## Sydney Western City Planning Panel Briefing Report

<b>Panel Reference</b>	PPSSWC-319
<b>DA Number</b>	DA-19/2023
<b>LGA</b>	Liverpool City Council
<b>Proposed Development</b>	Demolition of existing structures and construction of a three-storey centre based childcare centre over basement car parking accommodating 124 children
<b>Street Address</b>	73 Lachlan Street Warwick Farm
<b>Applicant</b>	FLDC Architects
<b>Owners</b>	Ben Nicholas Clint Biggs Robert Noyes
<b>Number of Submissions</b>	2 objections (1 containing a petition with 4 signatures)
<b>Regional Development Criteria (Schedule 6 of the SEPP) Planning System) 2011</b>	Private infrastructure and community facility over \$5 million – childcare centre
<b>Prepared by</b>	Nelson Mu Fineline Planning & Design on behalf of Liverpool Council

Figure 3 – Site plan showing the proposed building and landscaped area including deep soil zone.

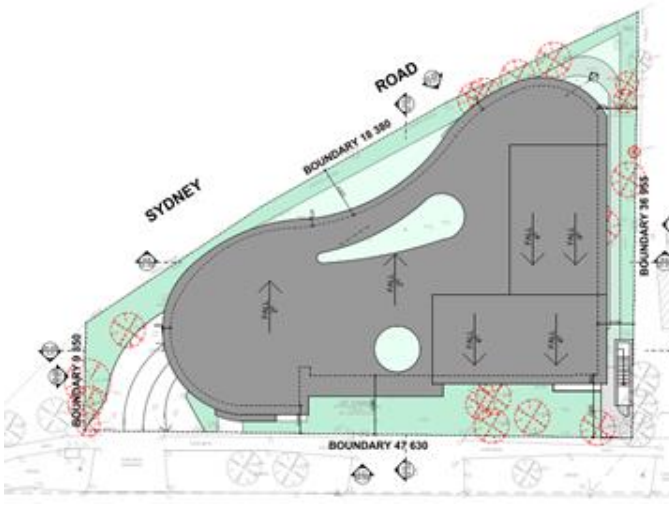
- Required setbacks:
- Hume Highway = 8m landscaped area
- Lachlan Street = 4.5m landscaped area

- Proposed setbacks:
- Hume Highway = 1.3m to 4.7m

The variation requested for the Hume Highway is not consistent with the DCP controls or the requirements of the Liverpool City Centre Public Domain Master Plan, which require the 8m setback to provide for mature height trees to provide a consistent green edge to the Liverpool city centre.

- Lachlan Street = 1.2m to 6m

- Deep soil zones and Site Cover
  - Max site coverage is 60% = 690m<sup>2</sup>

- Basement level:
  - 842m<sup>2</sup> / 1,150m<sup>2</sup> = 73%
  - The extent of site coverage proposed provides for minimal area for mature height trees to be planted in the development especially within the Hume Highway setback area.

Figure 4 – 2 levels of basement carpark

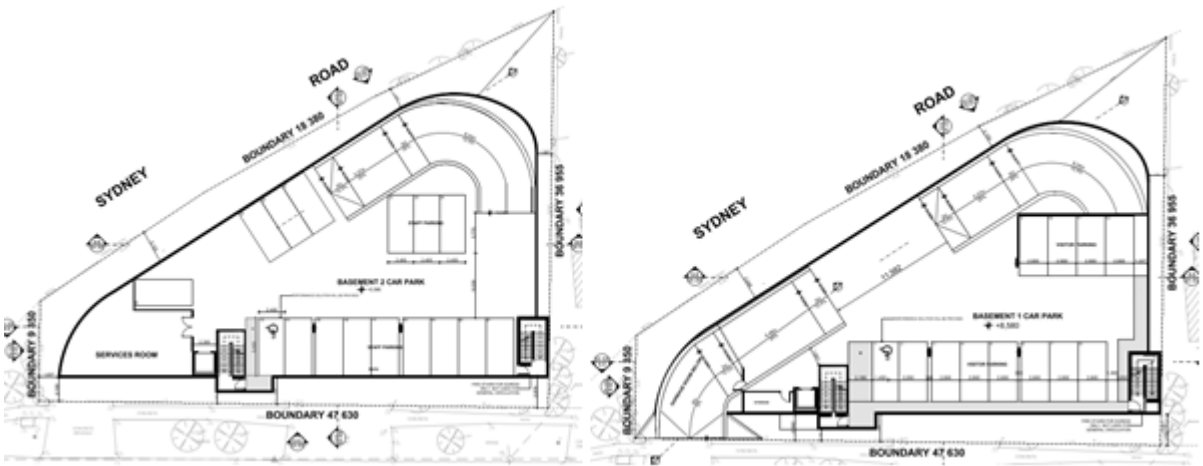
- The dimension of the boundary to Sydney Road is to be corrected on all of the plans to reflect the survey, as the 18.38m dimension is incorrect. The actual dimension should be 55.15m.
- Parking
  - o Shortfall of 5 spaces
  - o Manoeuvrability for a number of spaces is questionable.
  - o 1 accessible space may not be compliant with width required for shared area
  - o Space for service van / delivery vehicle turning area not provided  
NB - The parking shortfall is purely on the staff required by the teacher to age group requirement and does not include any ancillary staff. This needs to be clarified in the relevant reports and plan of management for assessment.
- Main Setbacks (front and rear)  
The proposal does not comply with the following minimum required setbacks.

- 3. The required landscaped area and deep soil zones remain deficient and do not comply, given that no changes are proposed to the basement carpark.*
- 4. A reduction in the number of children to be cared for by the child care centre may assist in resolving some of the issues.*

Figure 5 – Ground floor plan (outdoor children play area for aged group 0-3 is fully undercover)

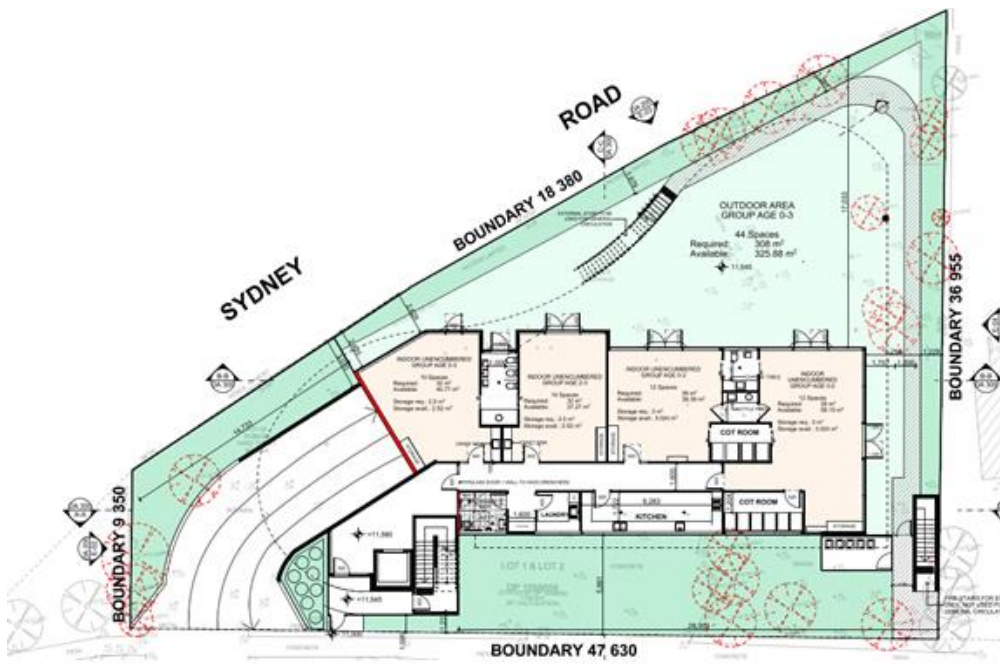
The proposal requires concurrence from the Regulatory Authority (acecqa) as the outdoor children play areas are undercover and not an outdoor space (Section 3.22 of SEPP (Transport and Infrastructure) 2021).

Having regard to noise attenuation recommendations provided within the acoustic report, the proposed outdoor space is required to be fully enclosed at Levels 1 & 2, and thus may not constitute outdoor space. In this regard, the outdoor space on these levels would constitute 'simulated outdoor environment'. Whilst this may be appropriate in the circumstances, particularly given that access to unencumbered outdoor space at ground level is available, concurrence from the Regularly Authority (acecqa) would be required in accordance with Part 3.22 of SEPP (Transport and Infrastructure) 2021.

### Acoustic Barrier

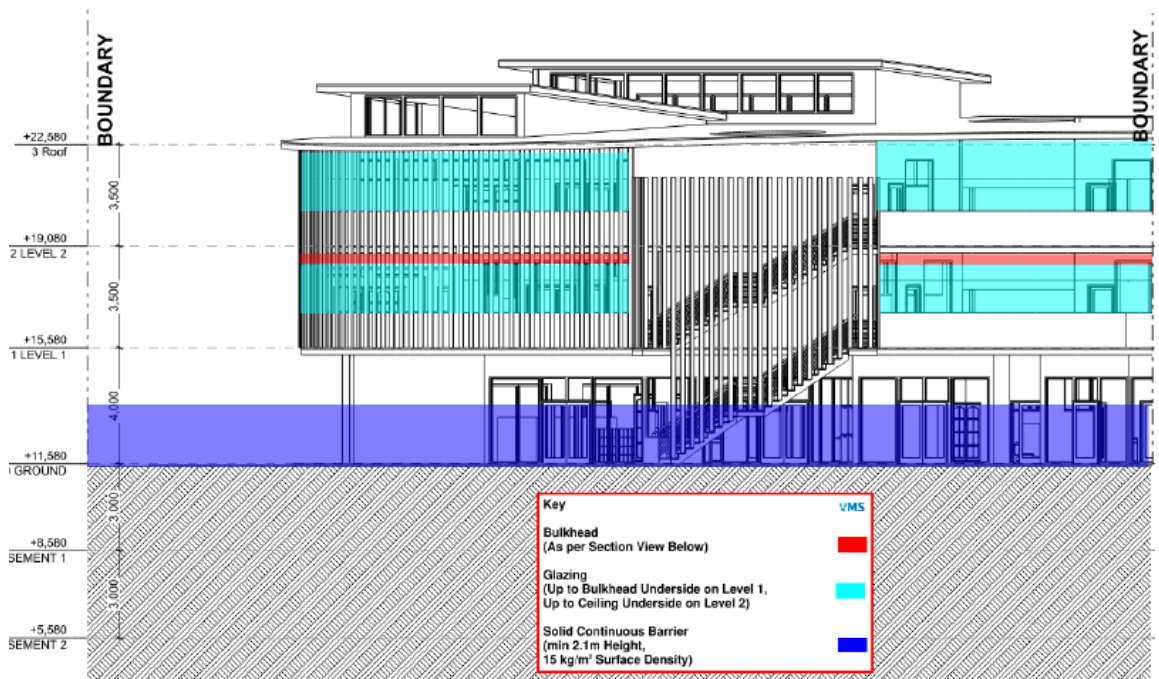
The acoustic report provided with the application requires a 2.1m continuous barrier along the boundary to Sydney Road which would present poorly to the approximately 55m street. This continuous fencing should be further articulated with landscaped areas to break up the blank barrier. Consideration of alternative designs for 2.1m acoustic fencing between the site to the east to reduce any amenity impacts.
